NUCLEAR REGULATORY COMMISSION
REGION III
799 Roosevelt Road
Glen Ellyn, Illinois 60137

LICENSE # 13-23543-01
CONTROL # 82559

In response to your letter dated March 11, 1987 requesting additional information concerning relocation of the Nuclear Medicine Department, I submit the following:

Exhibit VI
DiagramNUCLEAR MEDICINE

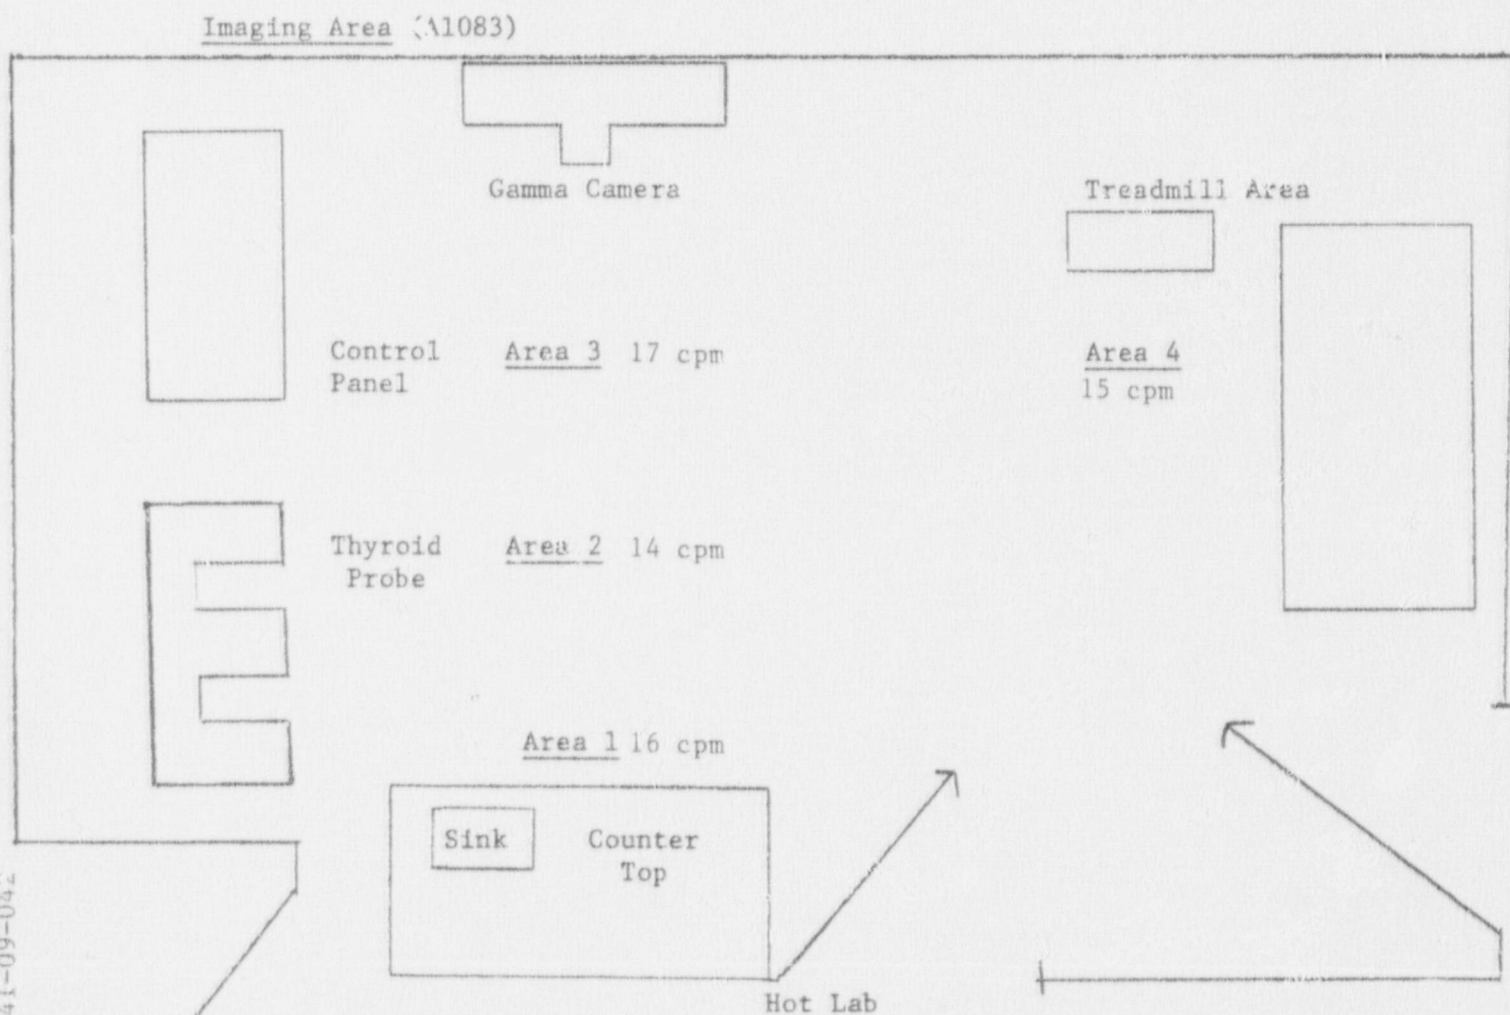
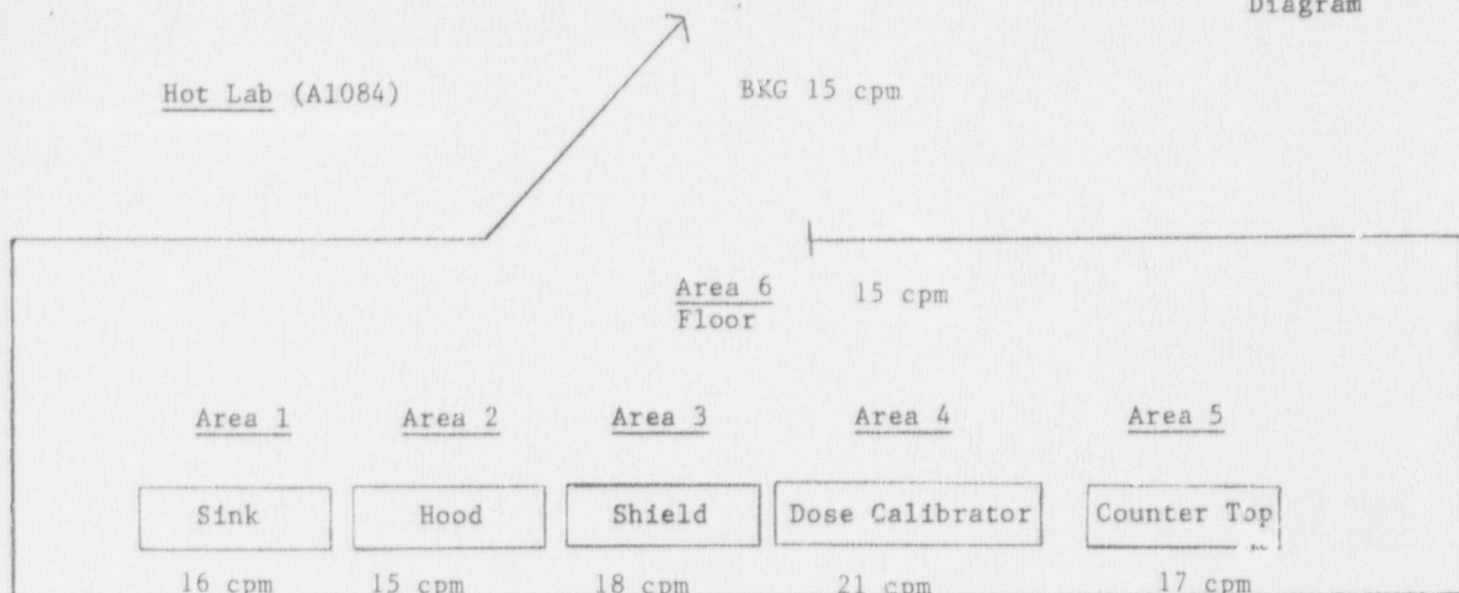
Final Gm Survey done on 9/19/86 by James C. Boesch R.T.N.M. The GM Survey meter is a Ludlum Model 14C calibrated on 1/2/86. Bkgd. readings were also < .1mr/hr. (The GM Survey meter has been recalibrated on 1/87).

ATTACHMENT D

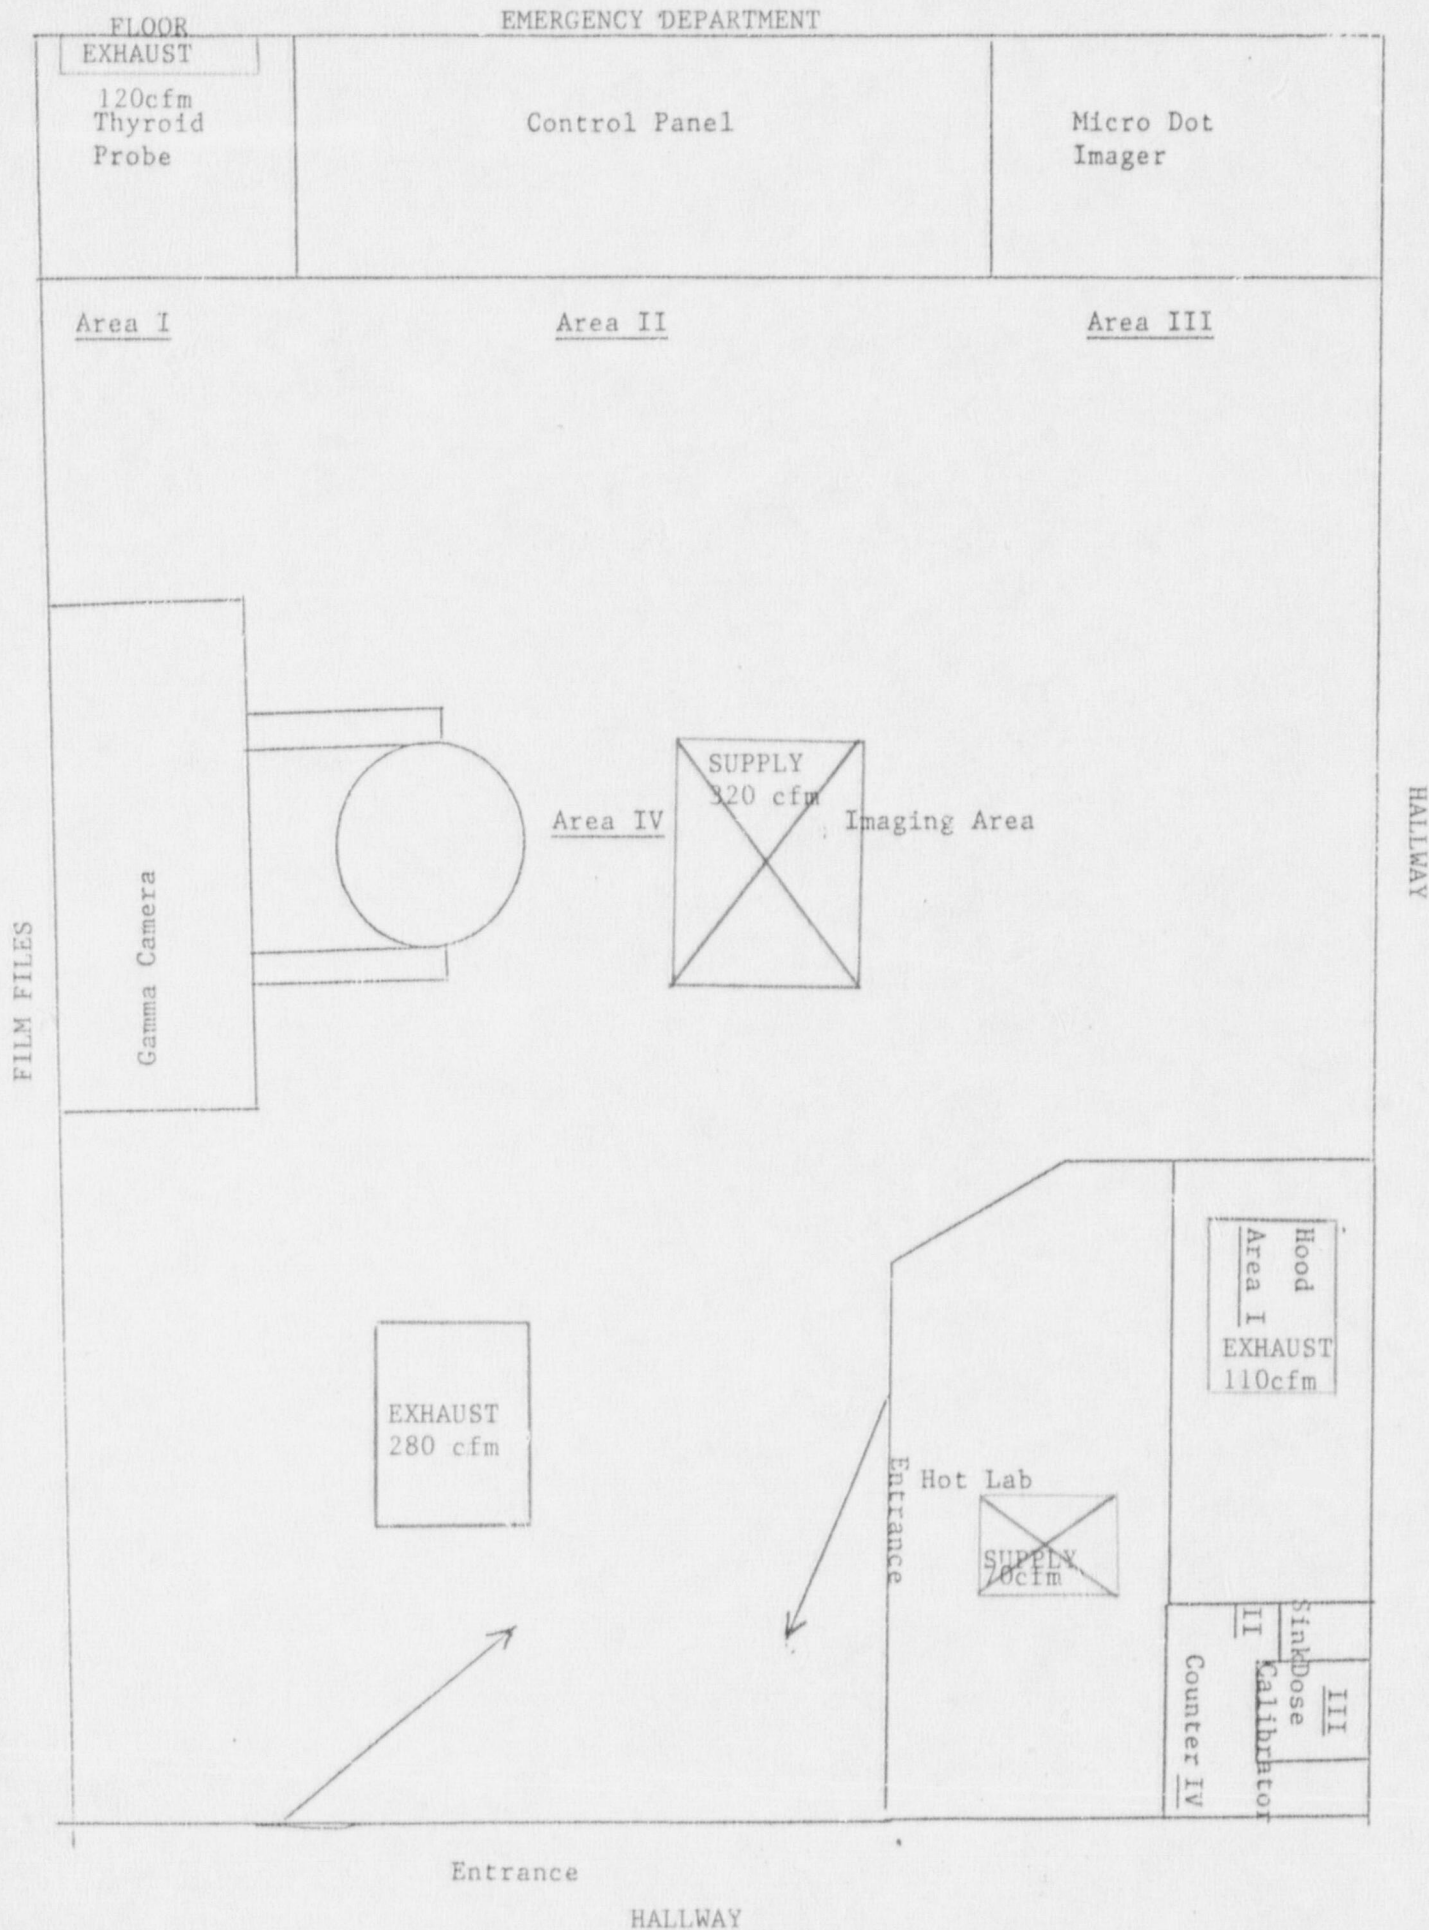
- A. XE #133 will be delivered in lead containers and stored behind lead blocks under the exhaust hood in the attached hot lab of the imaging room.
- B. Attached you will also find a diagram of the new Nuclear Medicine Department which indicates the supplied cfm and return cfm for the imaging area and hot lab. Consistent flow rates have been established and will be monitored on a quarterly basis by the maintenance department. (Attachment C).
- C. Xenon is only used within the restricted nuclear medicine imaging area. We estimate that the volume for XE studies to be approximately four patients/week @ an approximate dose of 10mCi. Attached please find the actual air flow and exchange measurements taken on the quarterly test using a newly calibrated air flow meter on March 27, 1987. (Attachment D).
